Attachment 10

Solar Access Compliance Assessment

THORNTON SENIOR LIVING DEVELOPMENT

DA-17-2593

PRIVATE OPEN SPACE SOLAR ACCESS DIAGRAM

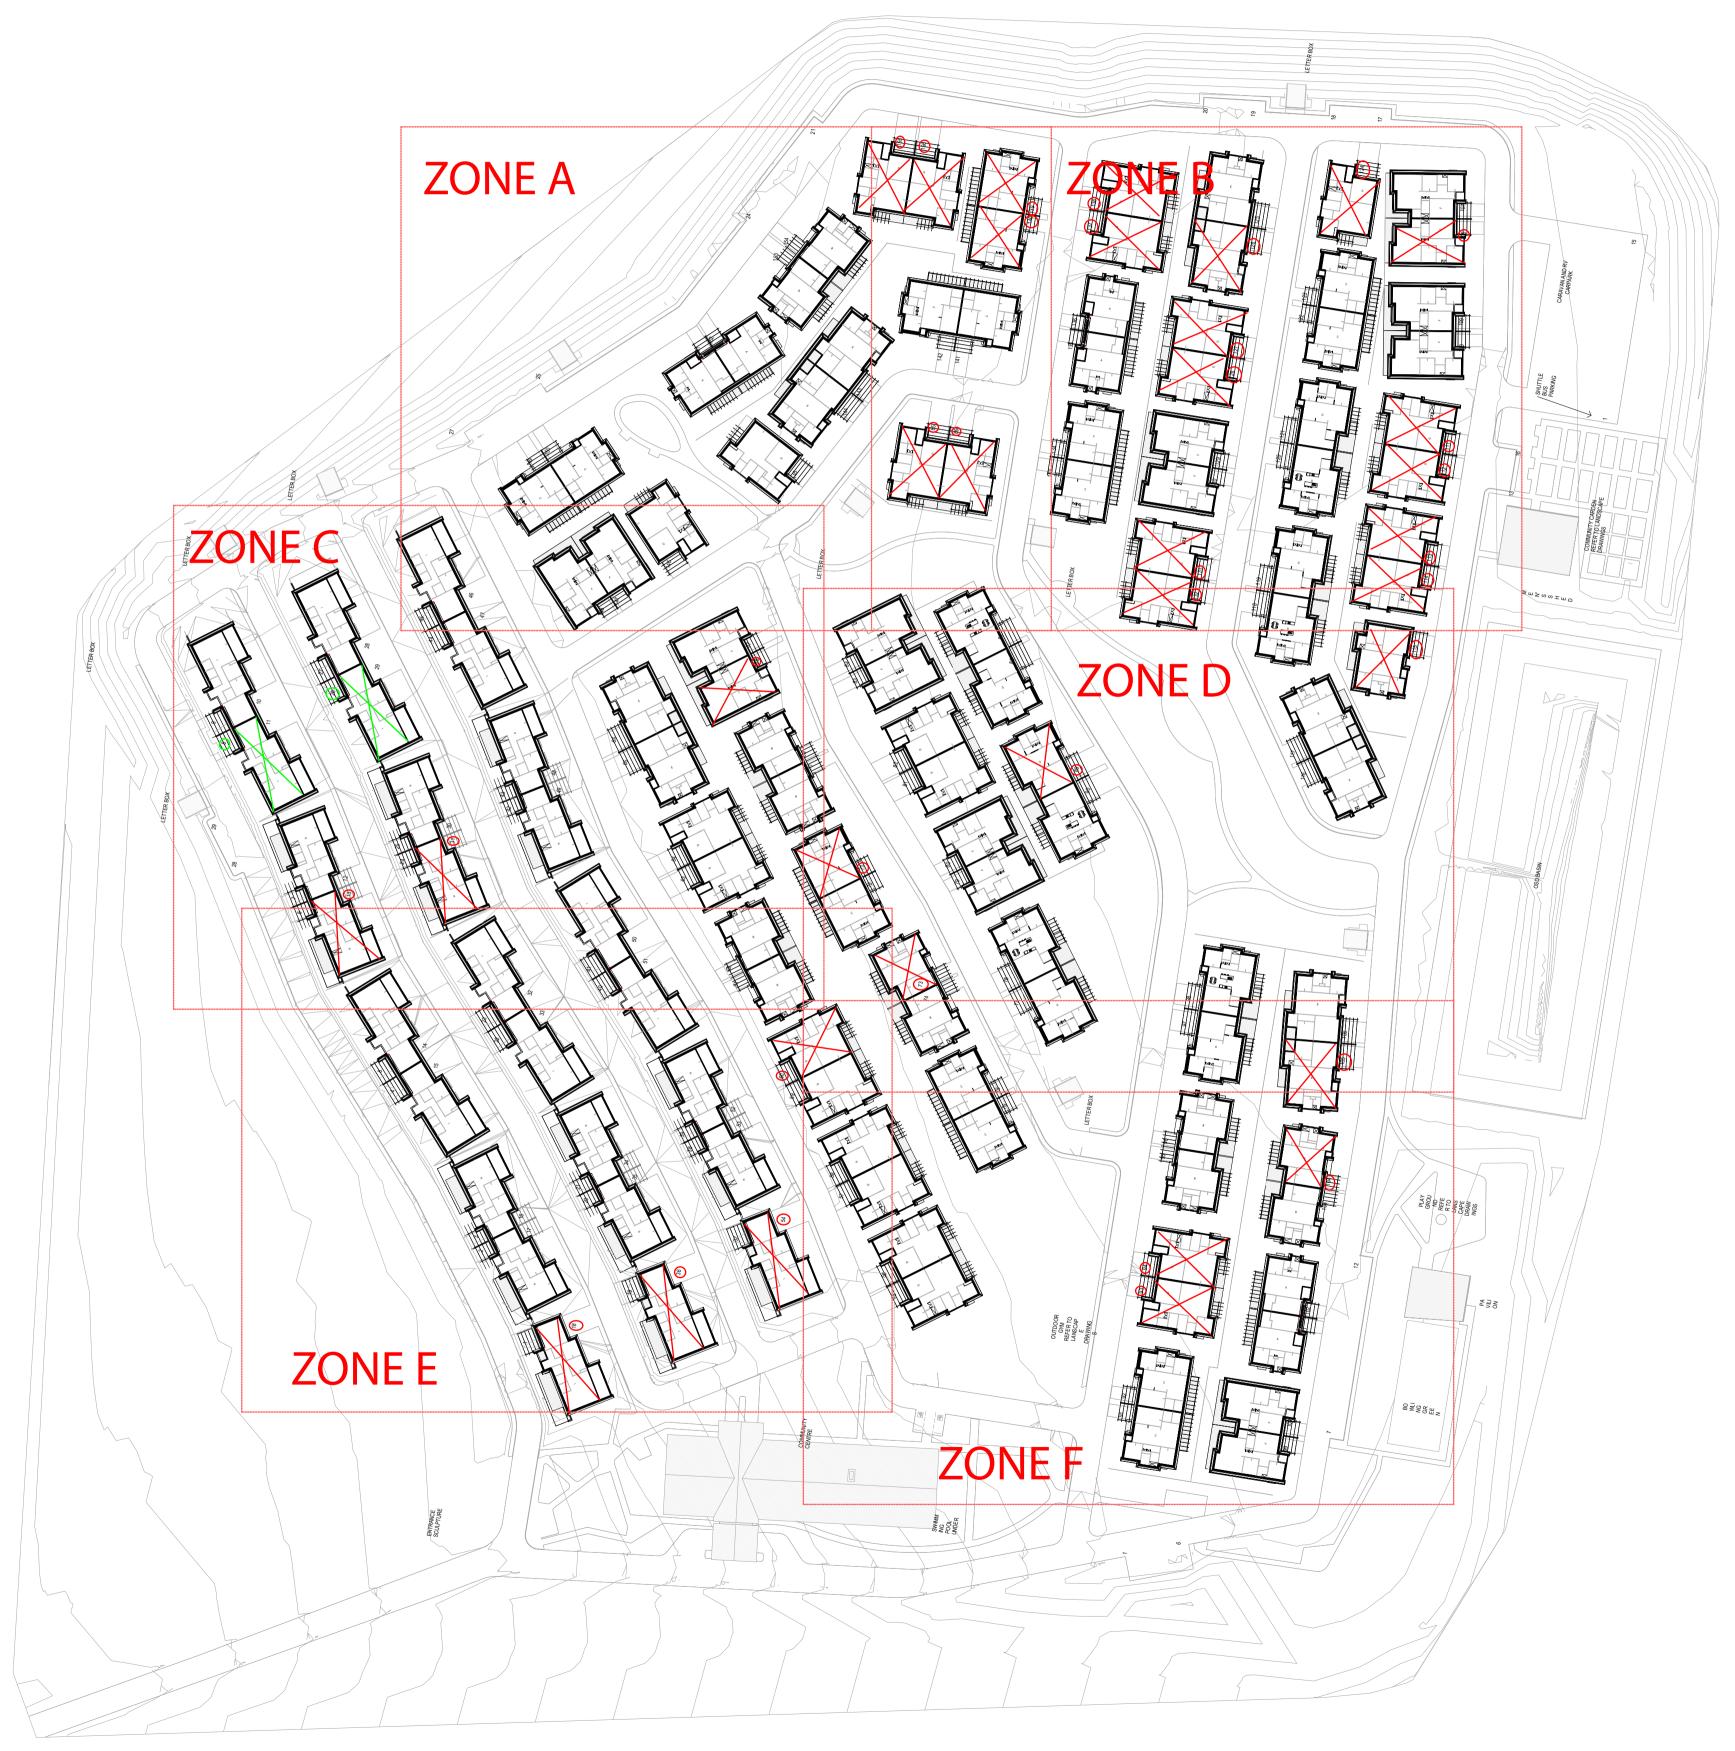
Council non-compliance (additional POS areas)

TOTAL = 21/156 do not comply with POS requirements.

Therefore, 135/156 comply = 86.6%.

THORNTON SENIOR LIVING DEVELOPMENT DA-17-2593
SOLAR ACCESS DIAGRAM KEY PLAN

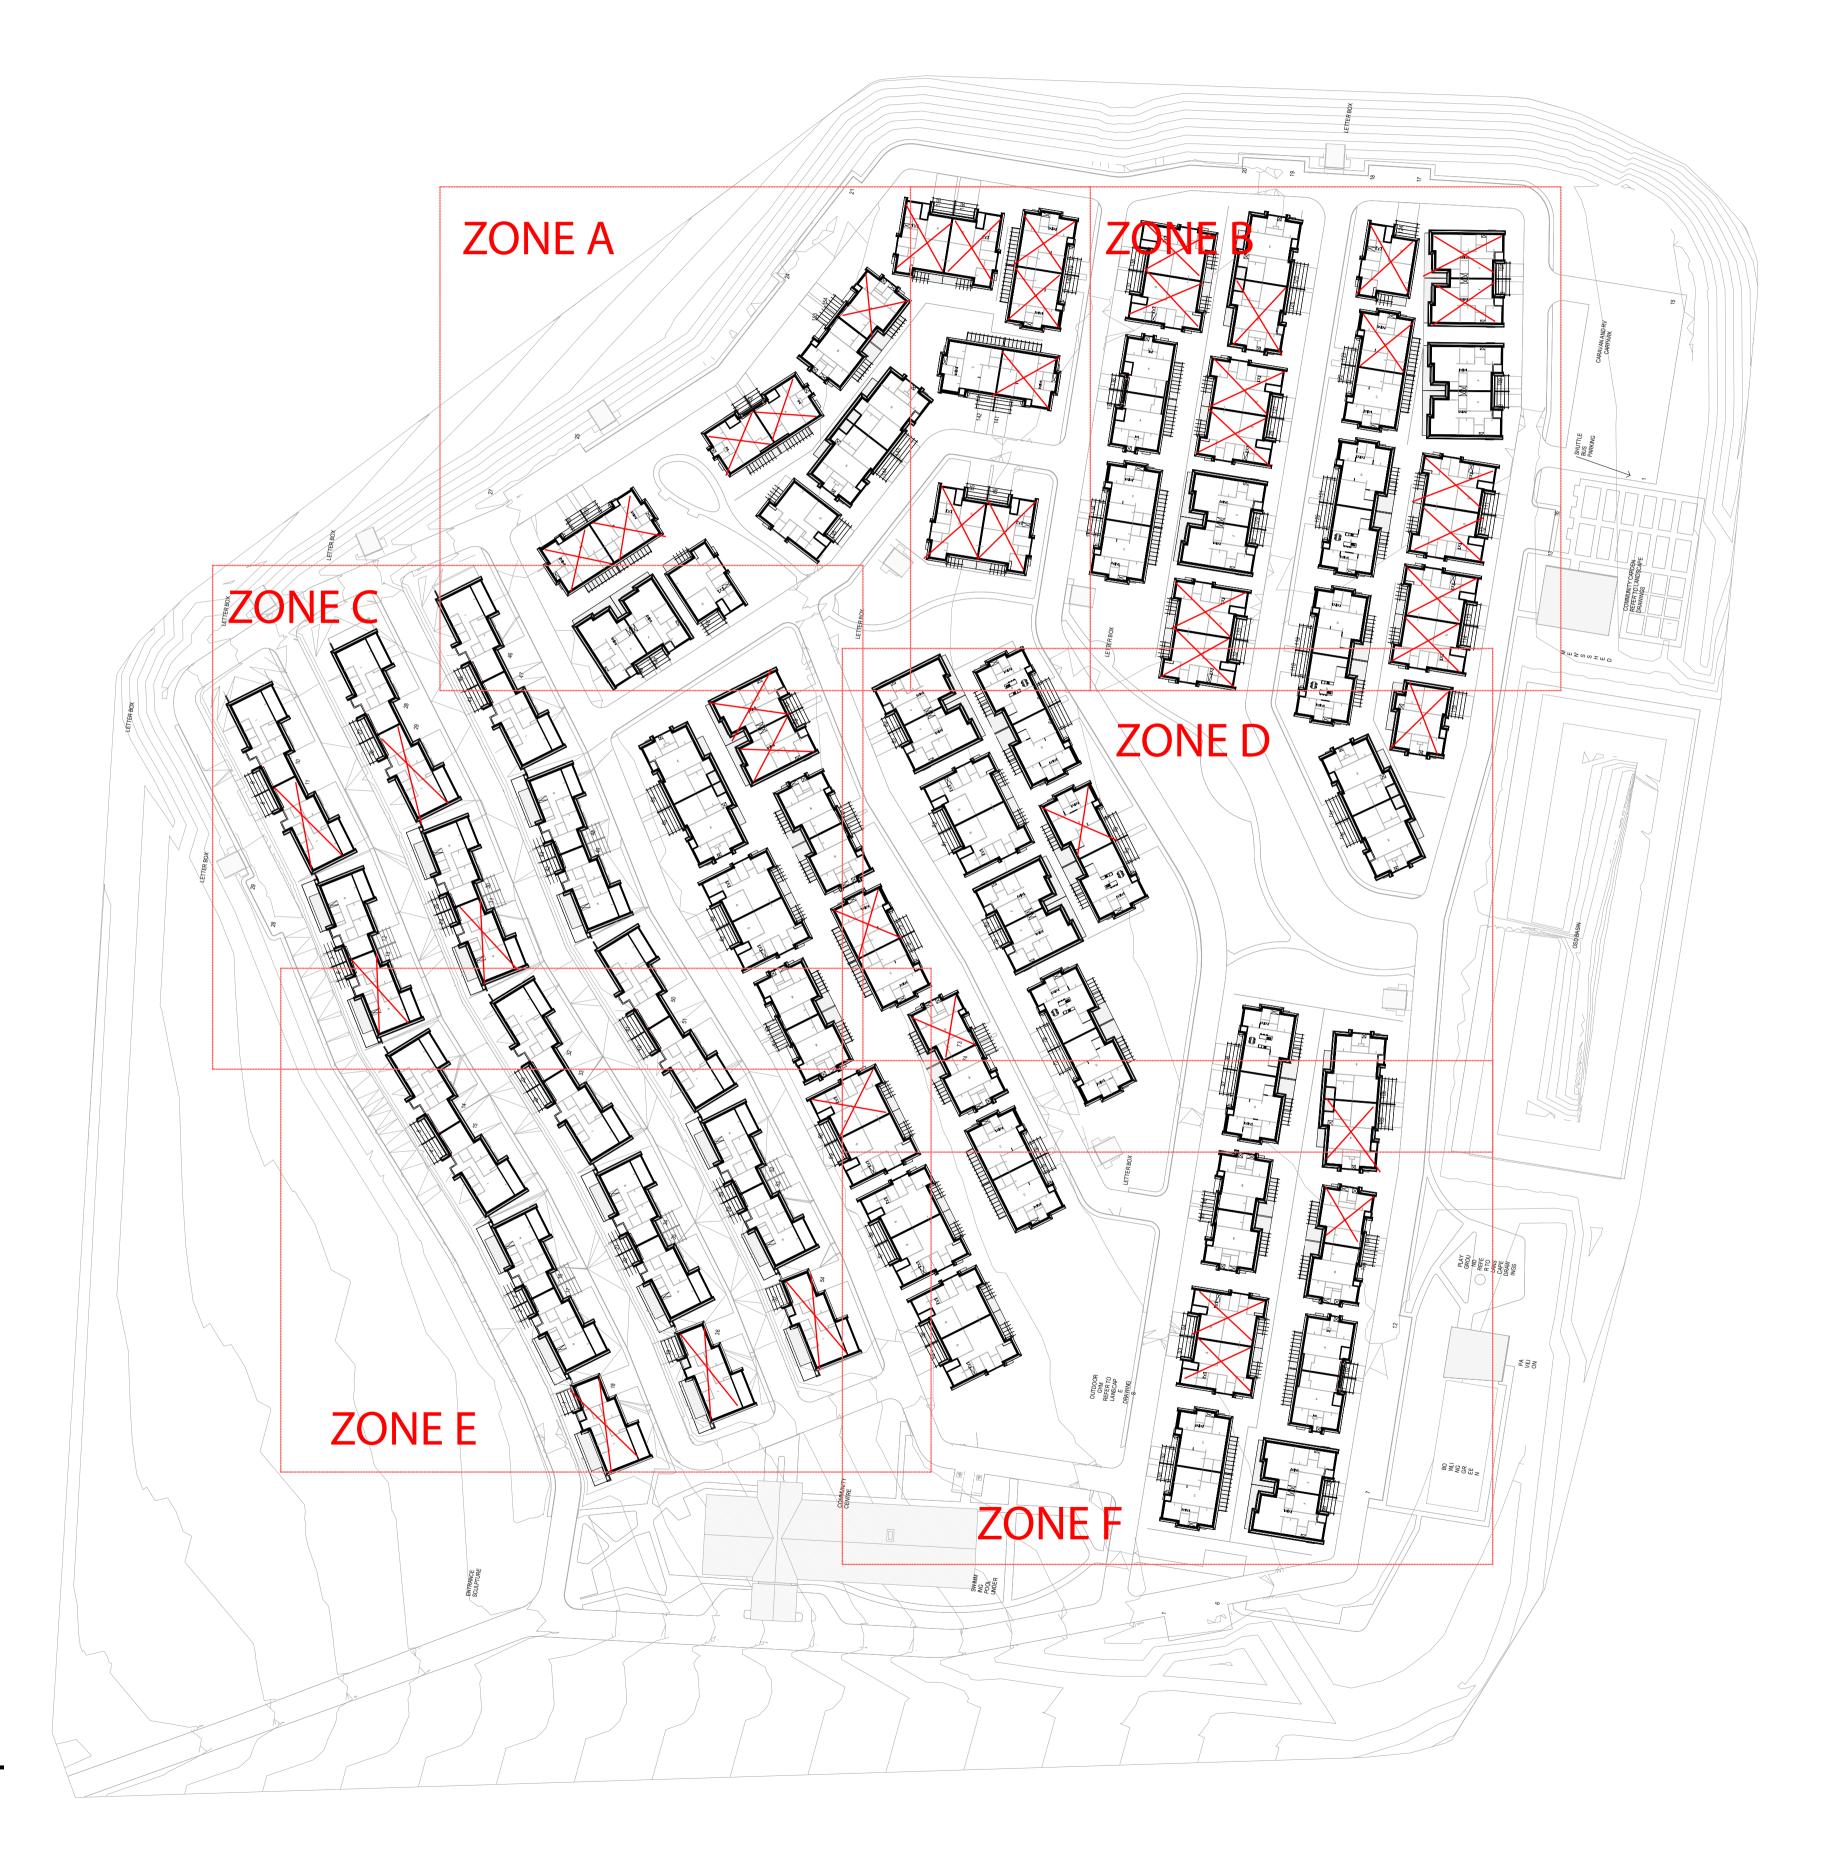
Total 36/156 do not comply with solar access into living areas.

Therefore, 120/156 comply = 76.9%

Combined Non-Compliance

44/156 dwellings and POS do not comply.

Therefore, 112/156 comply = 71.8%
